**North Liberty
Planning
Commission
Meeting Information**

John Hruby Revised Site Plan Request

Memo

To: North Liberty Planning Commission
From: Dean Wheatley, Planning Director
Subject: Revised Site Plan Approval Request
(Lengthy legal description)

1 PROPOSED SITE PLAN
 SCALE: 1" = 10'-0"

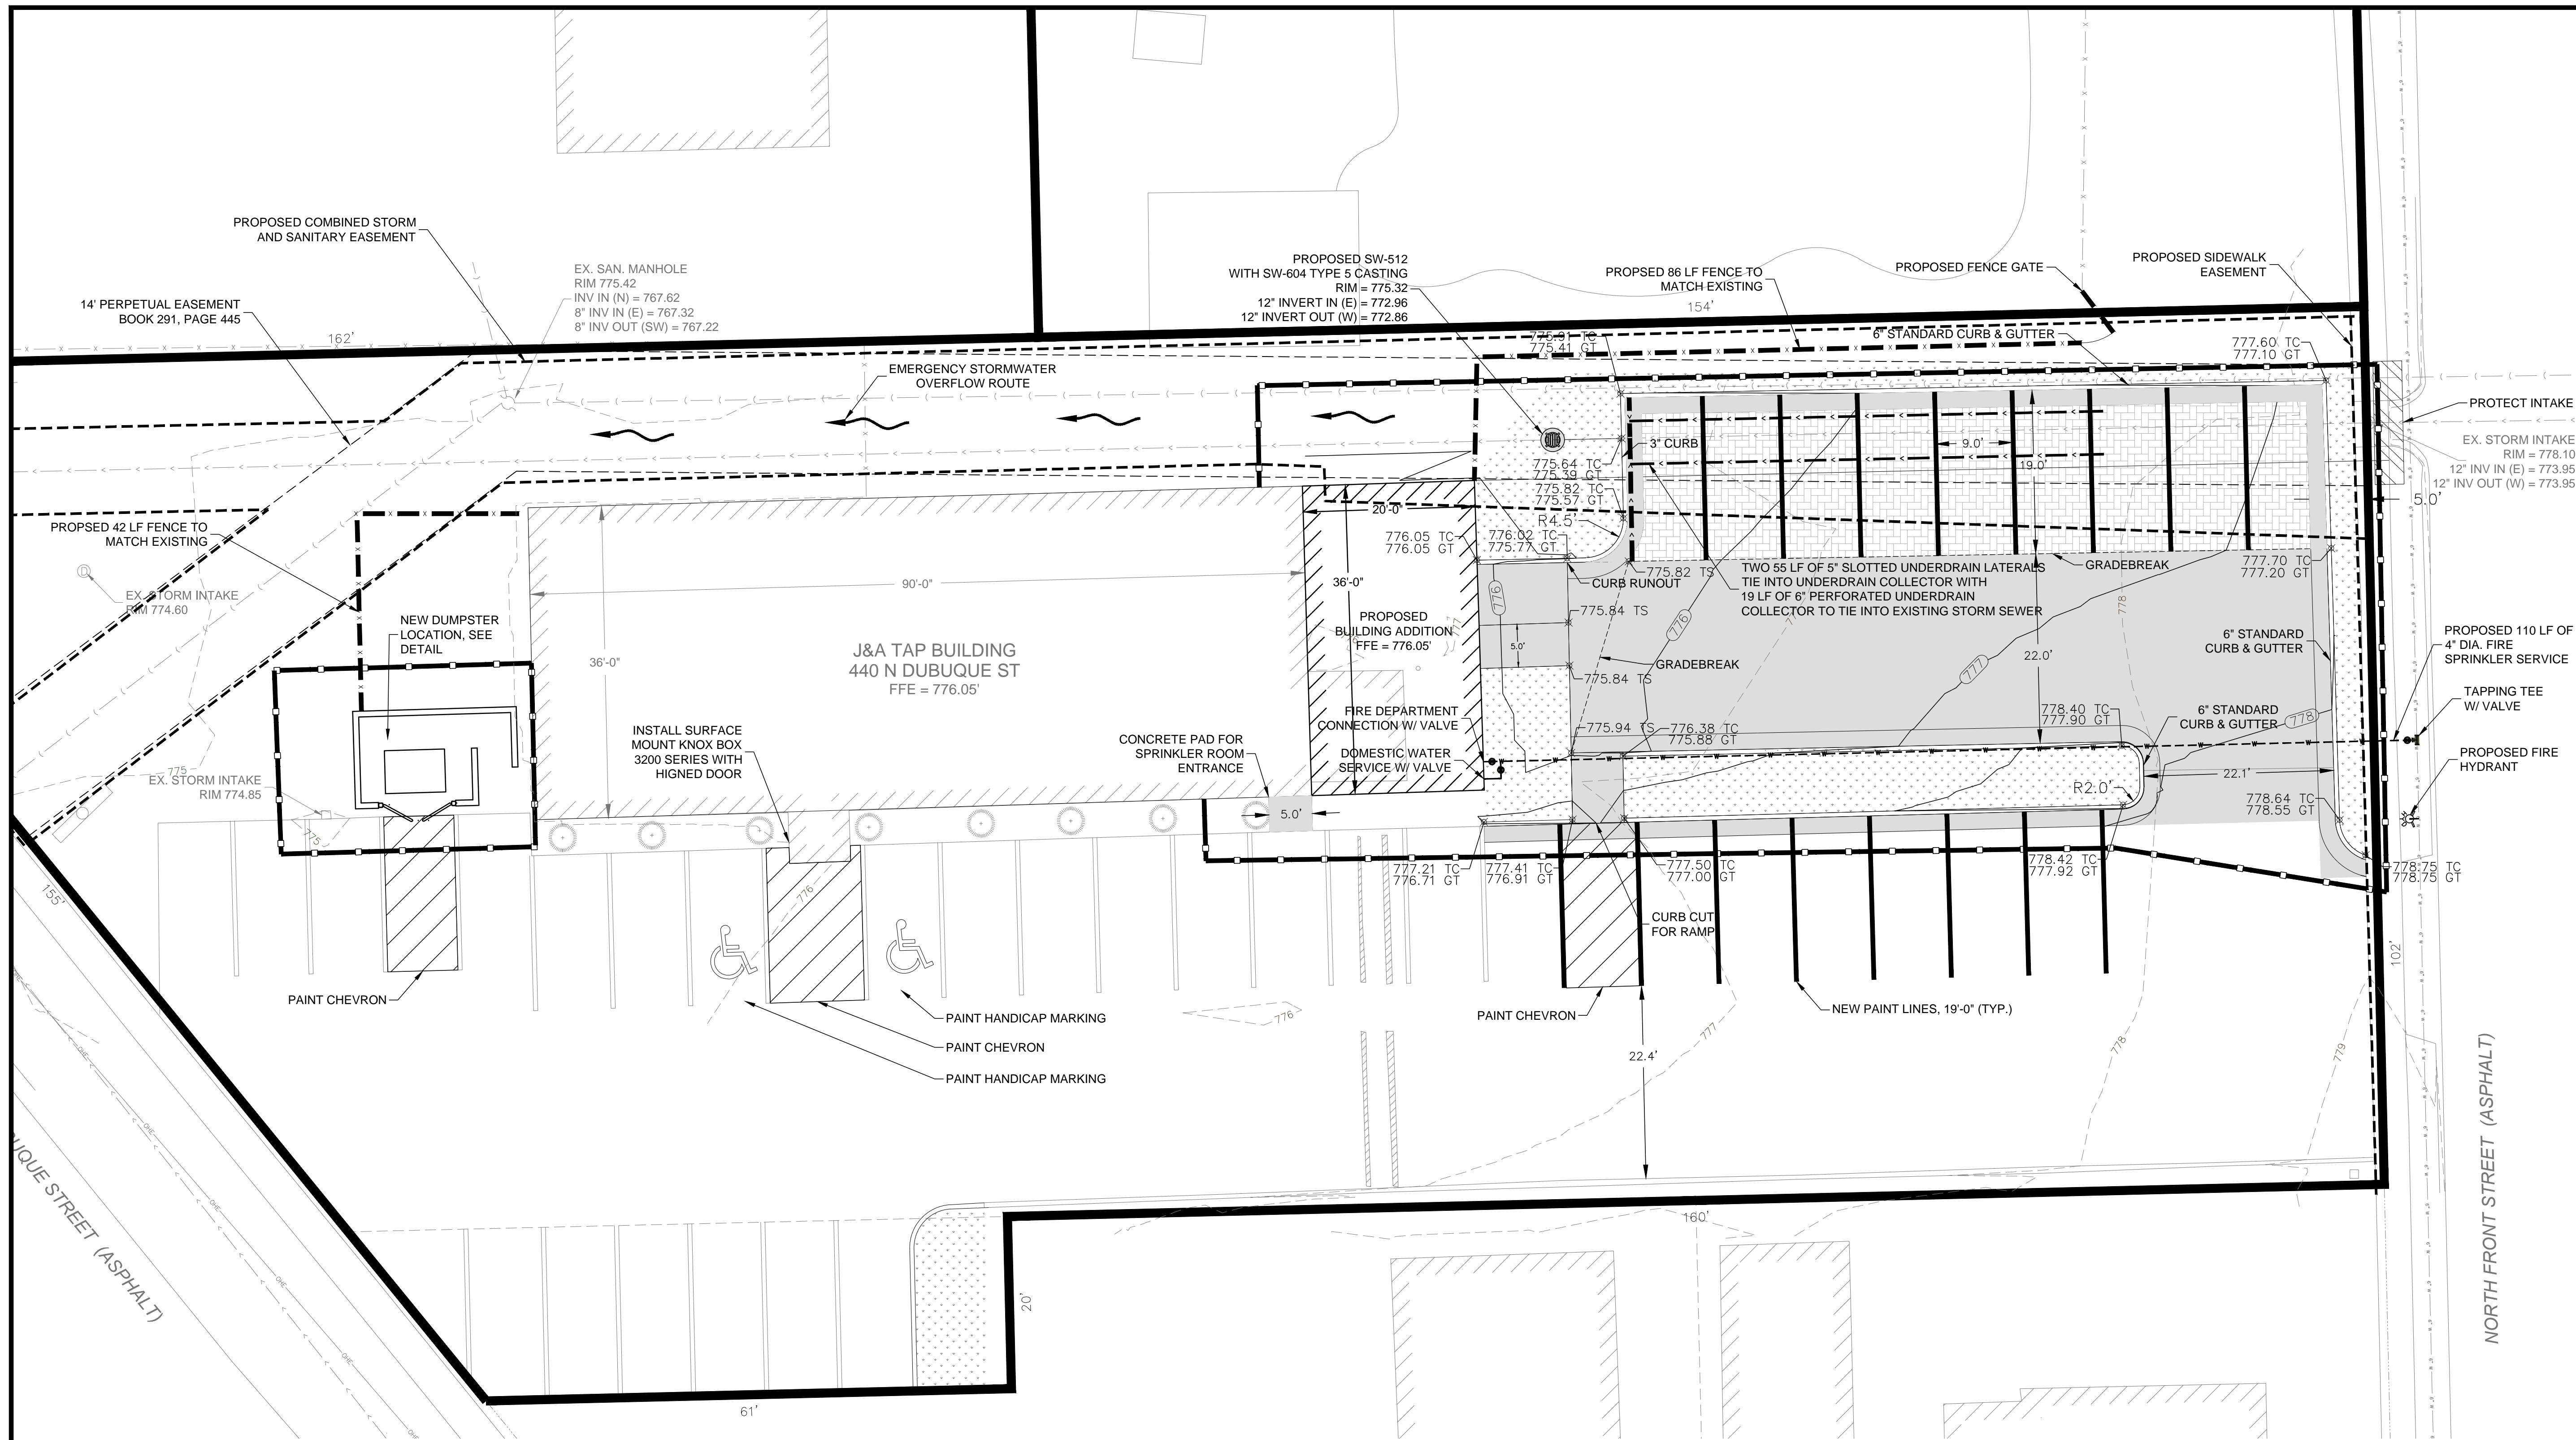
The plan includes many upgrades to the site including paving of the parking lot, landscaping, attractive garbage enclosures, and much better overall organization. Parking on site does not meet the City standard, but this area is served by a newer paved parking lot directly across Dubuque Street from this property that can be used by patrons.

The owners will need to formally waive City liability for any damage to the existing driveway, since it can't be verified to support the standard of 75,000 lb gross axle weight.
